TO: Application File #P20-00284-ECPA

RE: Response to Comments – Butler Vineyard Conversion
Agricultural Erosion Control Plan (ECPA) File #P20-00284-ECPA
Assessor's Parcel Number APN 033-190-006
No situs record; Wild Horse Valley Road, Napa
SCH #2022030347

LANDS OF BUTLER
RETENTION ANALYSIS
PRE-DEVELOPMENT

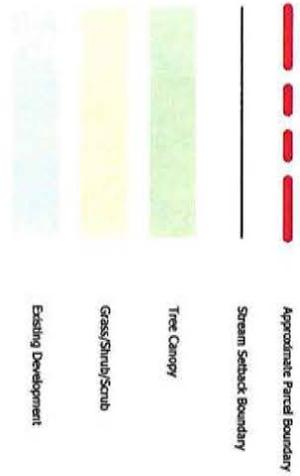
4. The project Revision Statement of the MND, dated 3/3/22 and signed by the Owner, W J Butler, describing Mitigations Measures BR-1, BR-2 and BR-3 requiring various conservation efforts for Nesting Birds, Wildlife Exclusion Fencing System and an Oakwoodland preservation area with permanent restrictions.

When will the Oakwoodland preservation area be designated on the project drawings? Will this require a Revision of the ECP Drawings?

Response to Comment 3.4: Refer to **Response to Comment 2.2**. Additionally, the Oak Woodland preservation area includes all tree canopy cover indicated on the Tree Retention Analysis, which has been updated pursuant to the revised (reduced) proposed development area, and included as Attachment 1, below.

- 1.) The 2018 conditions were used as a baseline due to the fact that the subject parcel was damaged by the 2017 Atlas Fire (Napa County Ordinance No. 1441)
- 2.) The project as proposed would remove a total of 0.95 acres of vegetation canopy cover outside of stream setbacks.
- 3.) Vegetation canopy cover outside of stream setbacks in the post development condition totals 2.85 acres, which meets the 3:1 preservation requirement in NCC Section 18.108.020(D).

Photodocumentation Location 1
August 6, 2020

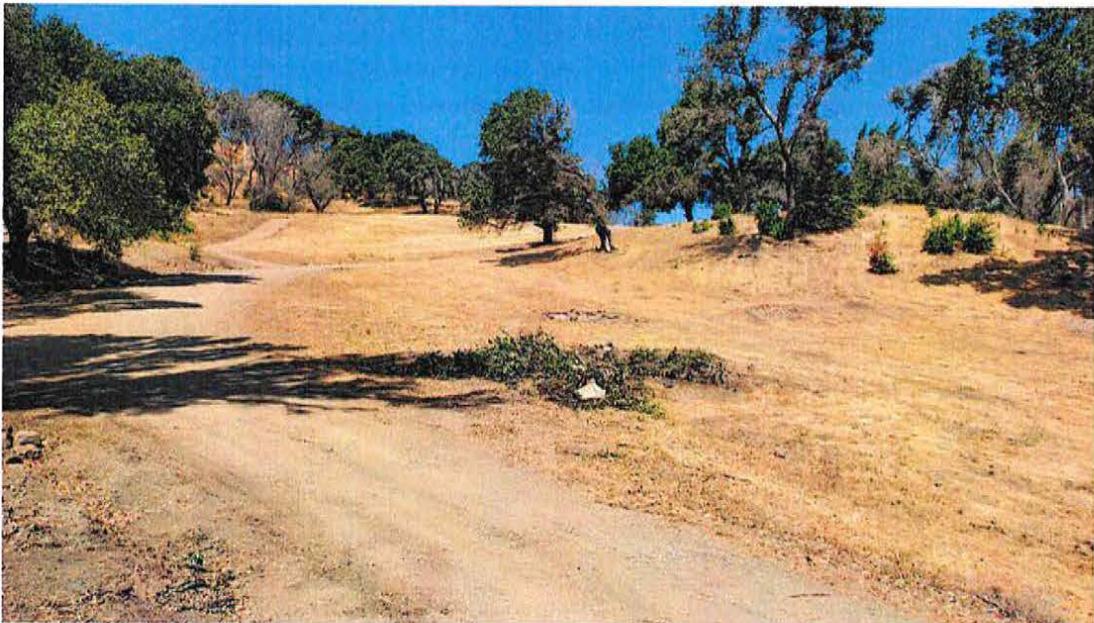
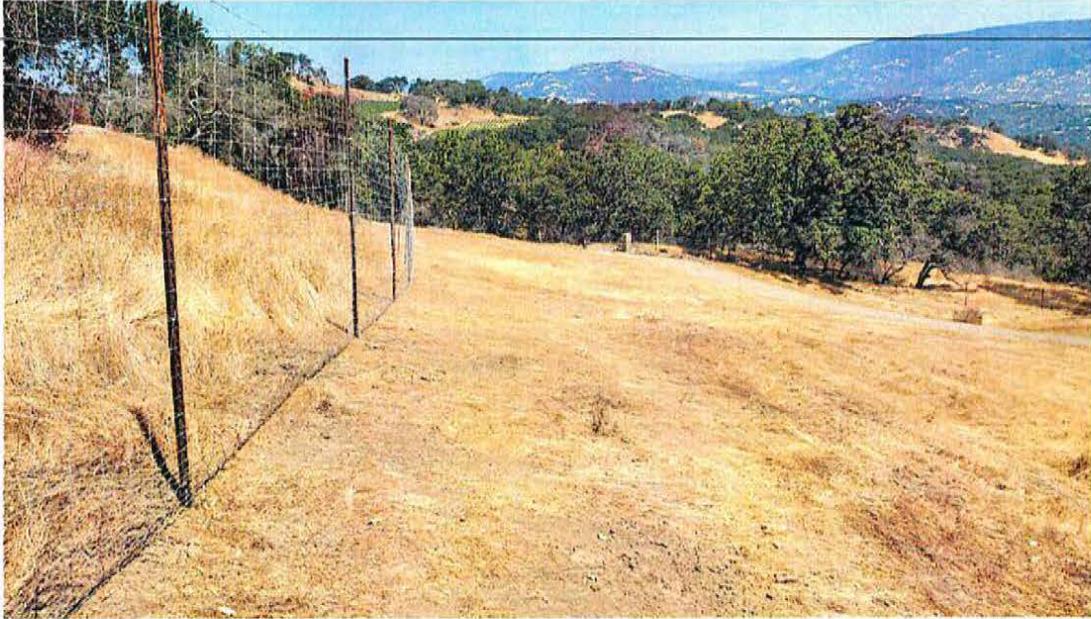
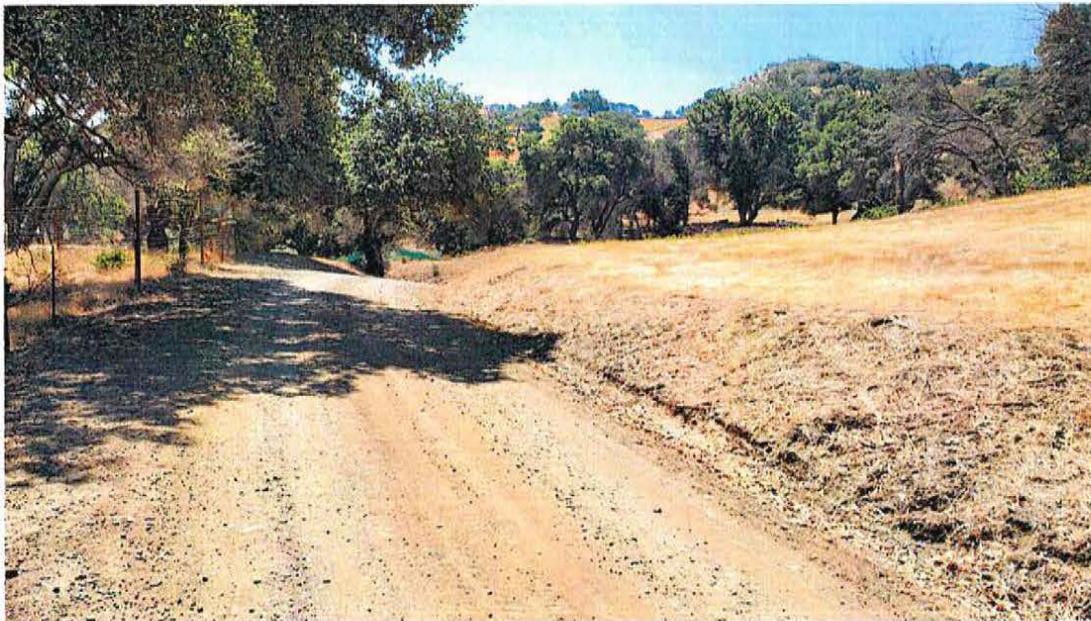
2. The Erosion control plans by Acme Engineering showed the location of 4 photos of the site, yet the photos were not included in the document. Again, public viewing was denied.

Response to Comment 3.2: Comment noted. The project application submittal materials included photodocumentation; that portion unfortunately was not included in Exhibit G of the IS/MND. The file has been included as Attachment 5 of this document. The site is also visible from publicly accessible Napa County GIS and Google Earth.
